Plan Commission

Agenda

SUBJECT: Consideration and possible action on a site plan for a 6,393 SF building addition with two loading docks at 675 Heritage RD (Parcel ED-F0094-1).

PLANT 5 ADDITION

OVERALL SITE PLAN

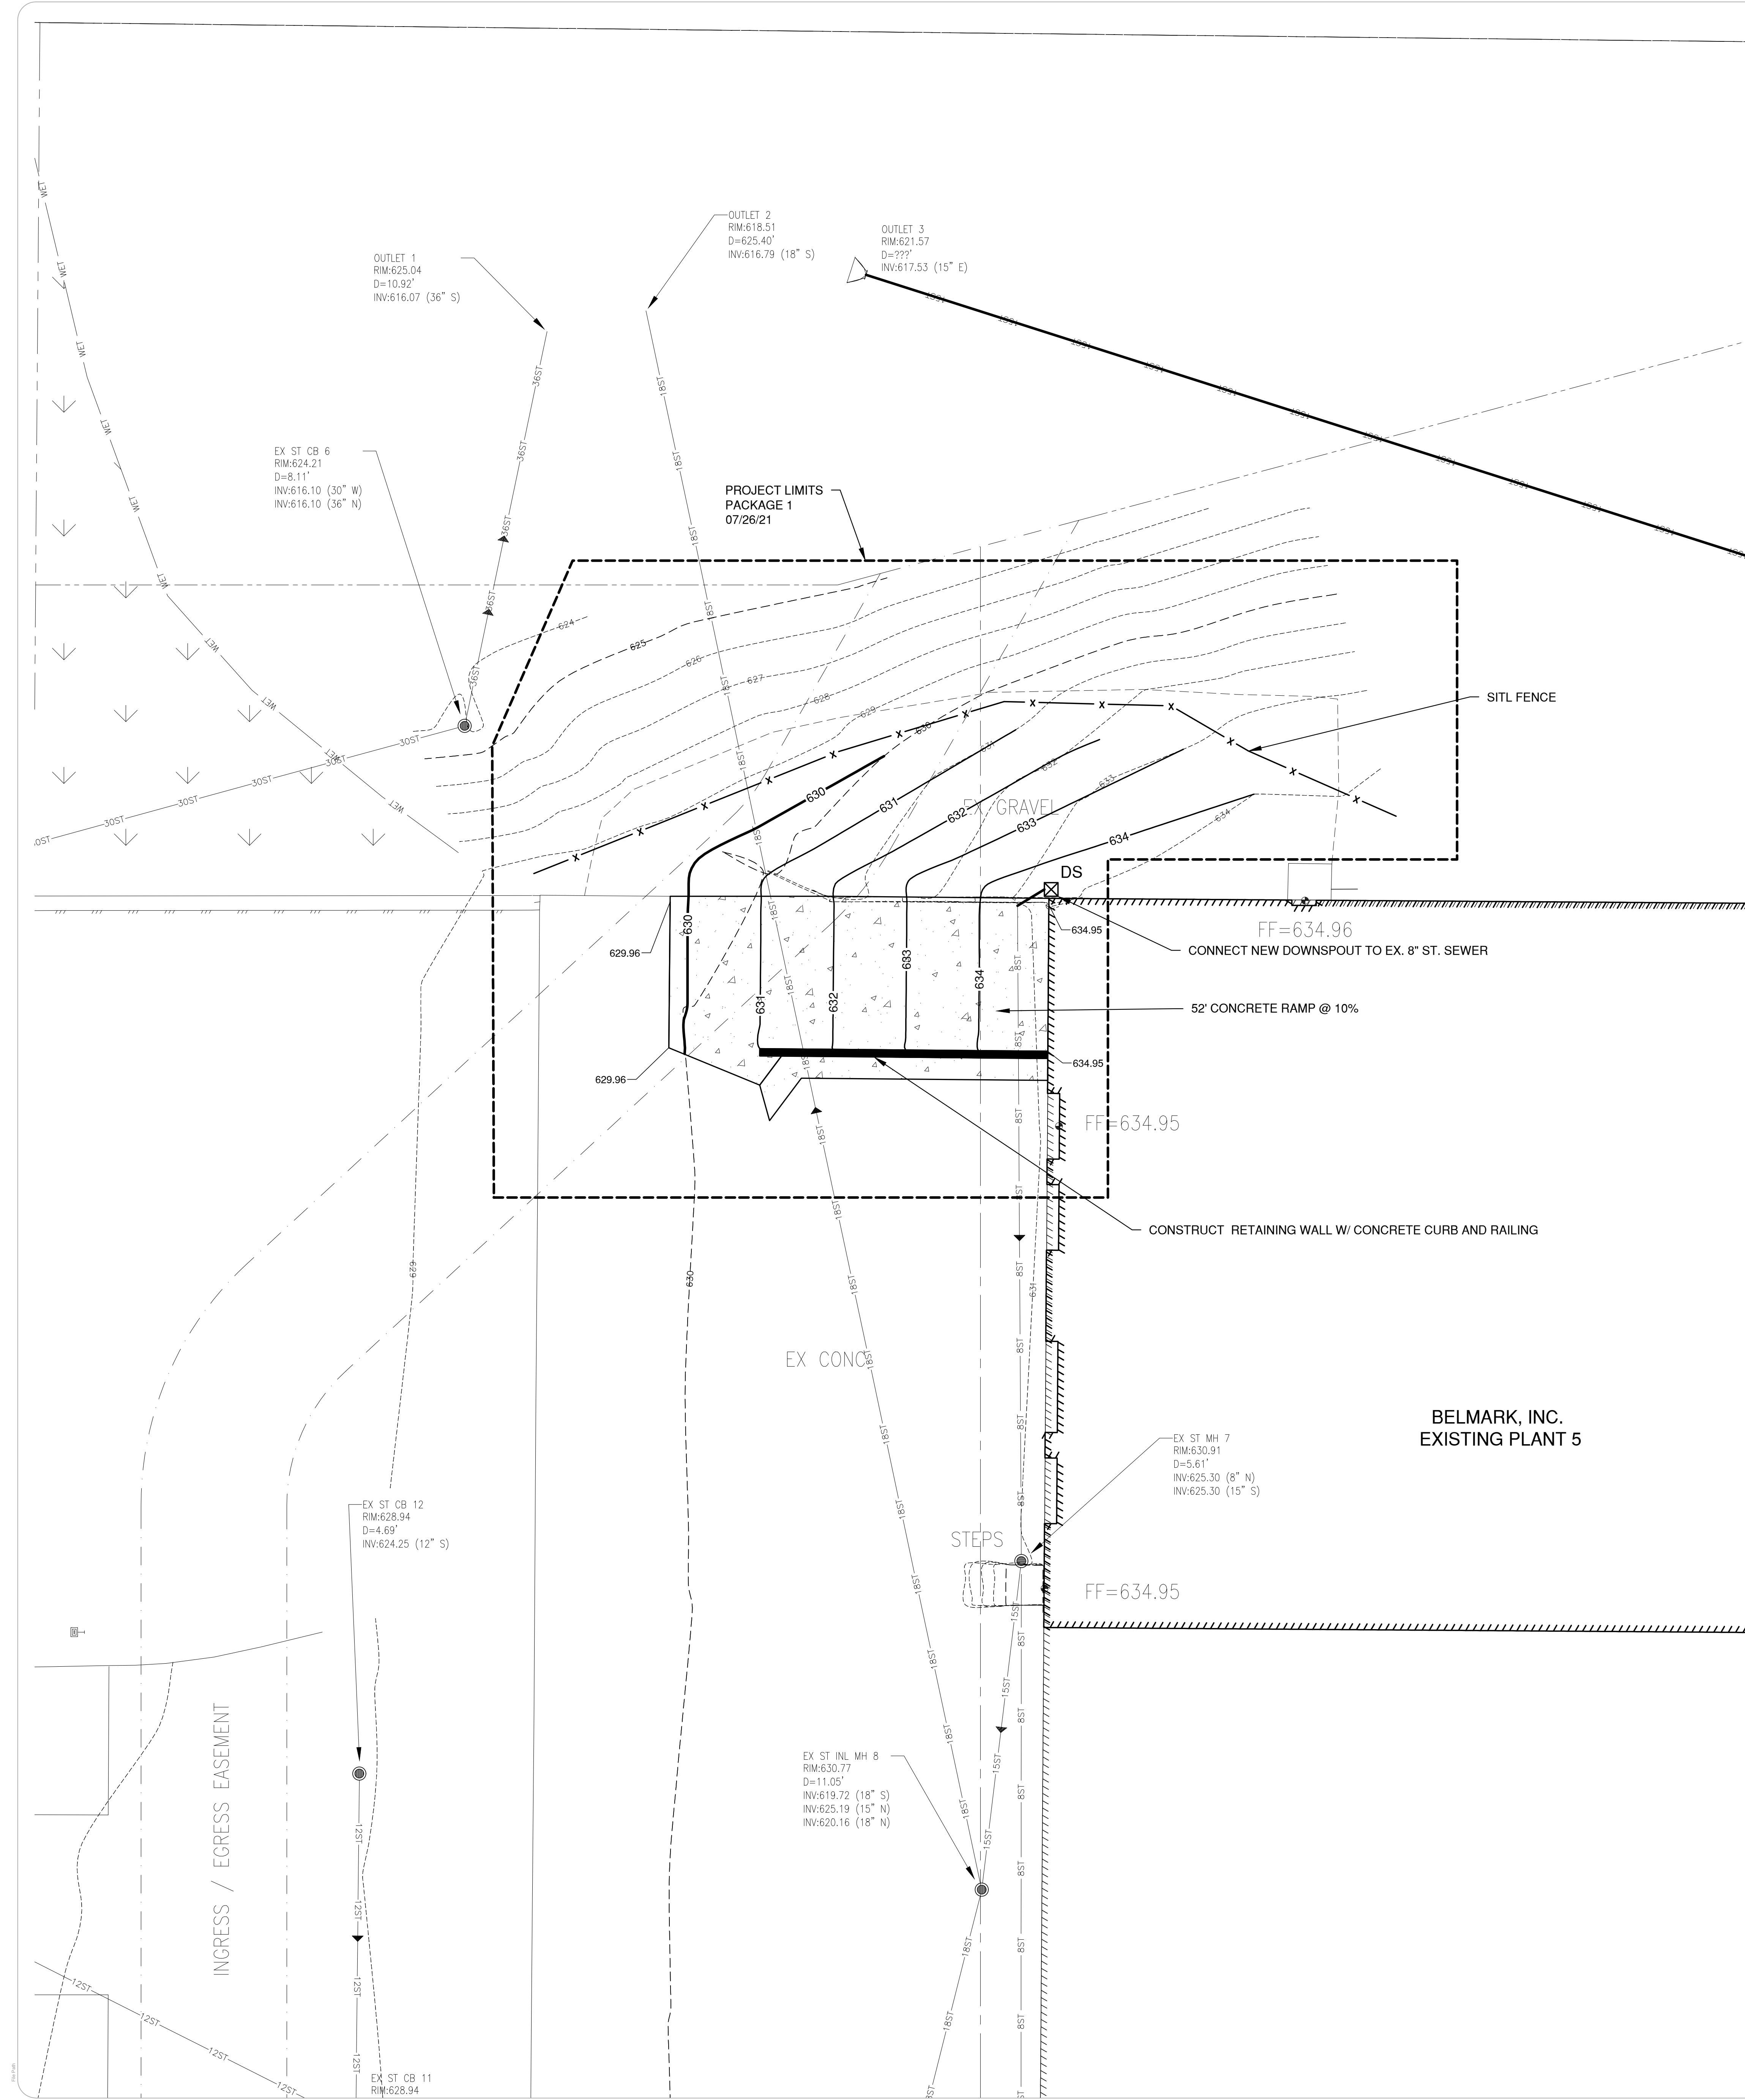
1. The building addition is causing the elimination of existing parking stalls. Verify and update the campus-wide parking stall count and requirements.
2. Identify the height of the loading dock screening (potentially part of the retaining wall or a landscape plan that was not included with submittal), which needs to be at a minimum elevation of five feet above the finished grade at the property line.

TITLE		CHKD		BDR	
DRAWN		PHK		SCALE	
DATE		07/21/21		AS NOTED	
DRAWING NO.		C104		REV.	
PROJECT NO.		21071		XX

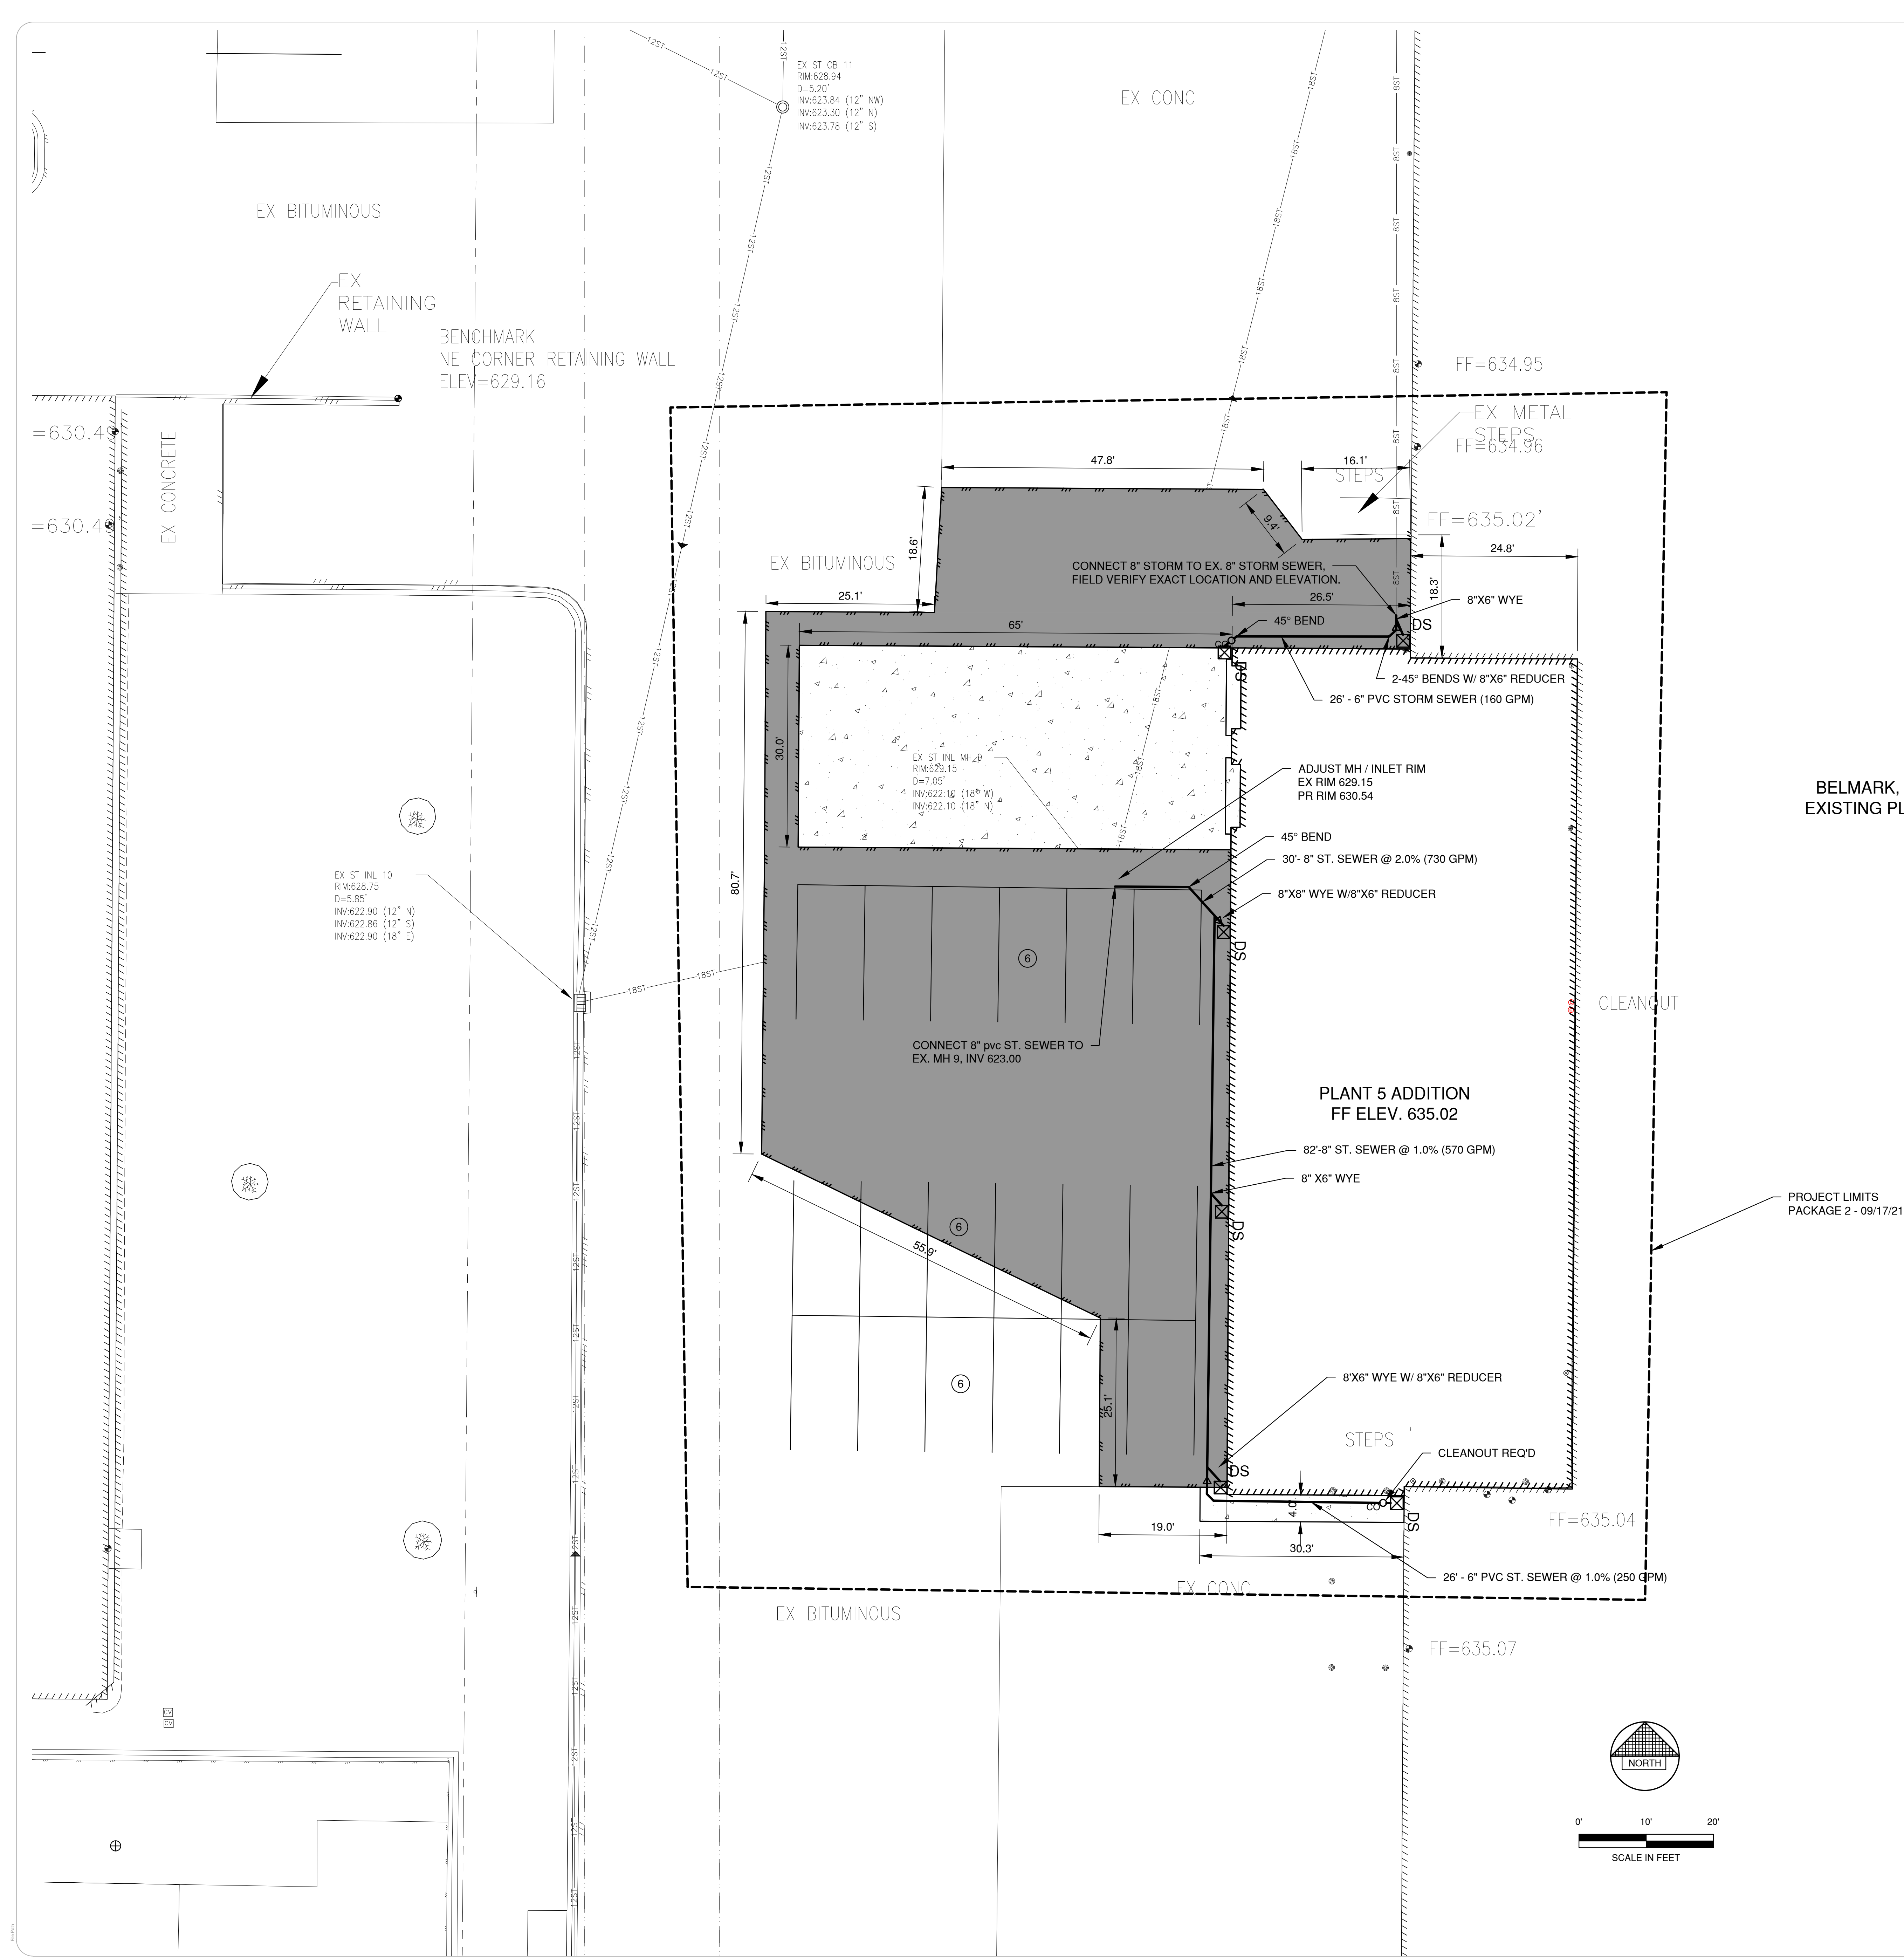
2. Sheet C101: In the Utility Information, remove Ledgeview Sanitary District as it is not present on this site.
3. Sheet C101: Remove demolition notes 4, 5 & 6 as they do not pertain to this project.
4. Sheet C104: Provide parking stall and aisle dimensions.
5. Sheet C104: The new asphalt layer is covering up the proposed storm connection and 18" storm sewer line.
